Work Order ID 111379

Item Name: Crosstube Turning Detail

DRAWING NO. D212-664-141	TITLE XTUBE ASSY (205/212/412 HI FWD)	REV. D	<b>DART AEROSPACE LTD ENGINEERING ORDER</b>		D.E.O. NO. D212-664-141-D-1	SHEET NO. SHEET 1 OF 2	SCALE NTS
DRAWN	CHECKED	MFG. APPR.	APPROVED	DE APPR.			
DATE 11.04.07	DATE 11.04.11	DATE 11.04.12	DATE 11/04/12	DATE 11.04.12

ADD AN INSPECTION WINDOW TO UNDERSIDE OF CROSSTUBE.

**D212-664-141/-141B  
ASSEMBLY DETAIL**

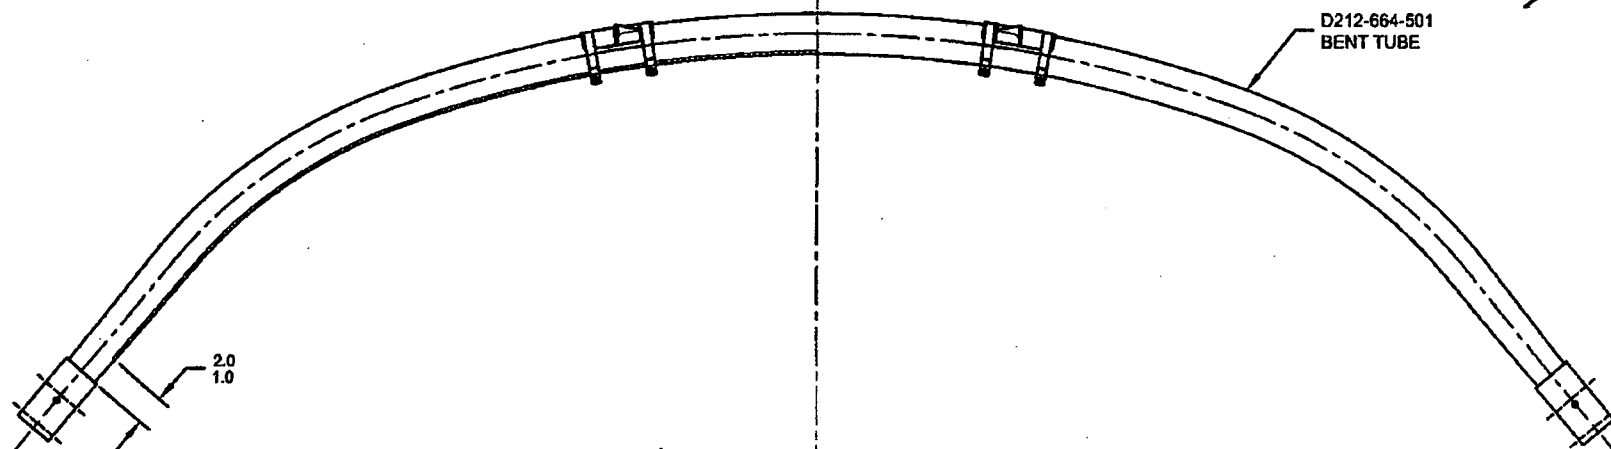
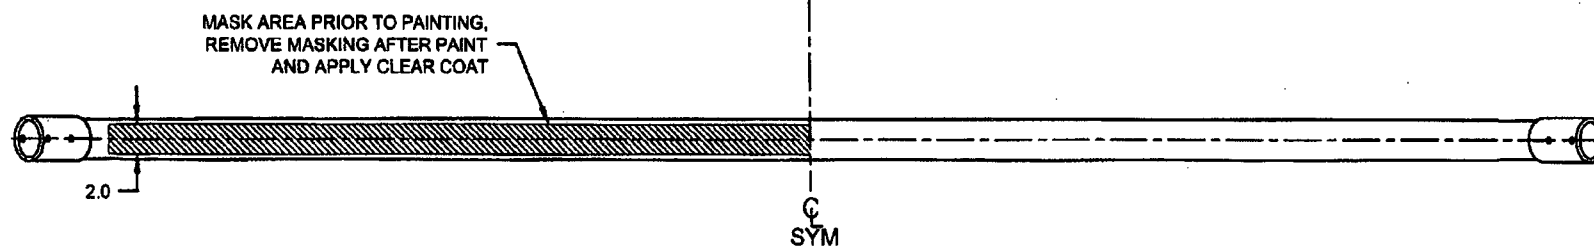
NOTES 2 OF SHEET 1 IS AMENDED AS FOLLOWS:

- 2) FINISH: CHEMICAL CONVERSION COAT PER DART QSI 005 4.1  
PRIME INSIDE AND OUTSIDE PER DART QSI 005 4.2  
MASK UNDERSIDE OF CROSSTUBE AS SHOWN (HATCHED AREA) AND  
PAINT OUTSIDE PER DART QSI 005 4.2  
REMOVE MASKING AND APPLY CLEAR COAT
